Tesla, Inc. Service Bulletin		<h2 style="margin: 0;">Inspect Front Spring and Damper Assembly Insulators</h2>	
SB-20-31-003 June 25, 2020			
Classification		Section/Group	Mobile Service
Campaign Bulletin		31 - Suspension	Cannot Perform
Model Year	Model	Country/Region	Version
2020	Model 3	China	All
<small>The model(s) and model year(s) listed are a general approximation of the affected VIN list. Refer to the VIN/Bulletin Tracker or Customer/Vehicle profile to determine applicability of this bulletin for a particular vehicle.</small>

Figure 1

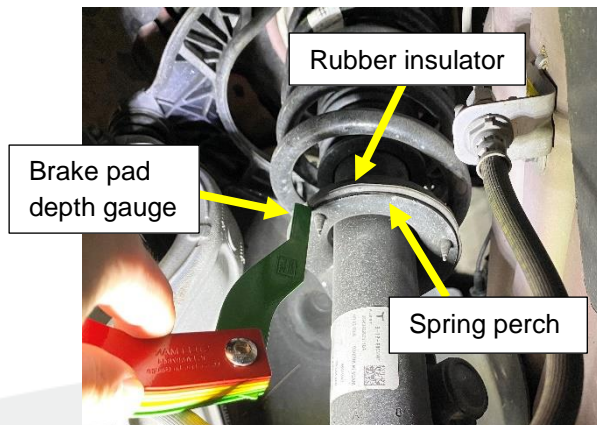
2. Use the brake pad depth gauge to inspect the protrusion of the rubber insulator at the spring perch of both the LH and RH front spring and damper assemblies (Figure 1):

- **✓** If the insulator is uniformly spaced on the spring perch and at no point protrudes more than 10 mm from the perch (Figures 2 and 3), that spring and damper assembly is within specification and does not need to be replaced. If both spring and damper assemblies are within specification, lower the vehicle and discontinue this procedure.

- **✗** If the insulator is unevenly spaced on the spring perch and protrudes more than 10 mm from the perch (Figures 4 and 5), that spring and damper assembly is outside of specification and must be replaced (refer to Service Manual procedure [31151002](#)).
